Technical Bulletin 134

**Communications Module Sulfide
Contamination Issue**

Version 1.33, Revision AC (29 December 2005)

Photo of RS-485 Module
with Silicone Based Coating

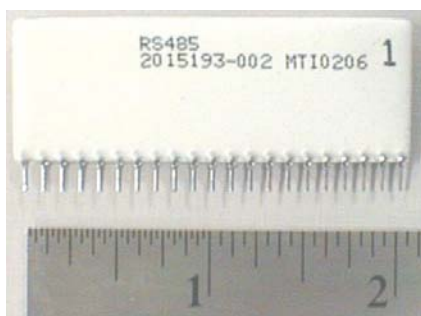
Modules can stop communicating or sporadically transmit data (chirping) during the power-up listen cycle when using Totalflow protocol. The sporadic transmission of data is typically caused when the communication module loses the ground connection on pin #21 of the module. We have found several modules where the ground clad was eroded away when H₂S reacted with the silver substrate located under the silicone coating.

Totalflow has been providing a more robust coated module for most of 2005. This coating is a Stycast (hard "Black") material that can withstand higher concentrations of H₂S and other chemicals. Stycast is now Totalflow's standard coating and is recommended for any installation where high concentrations of H₂S are present.
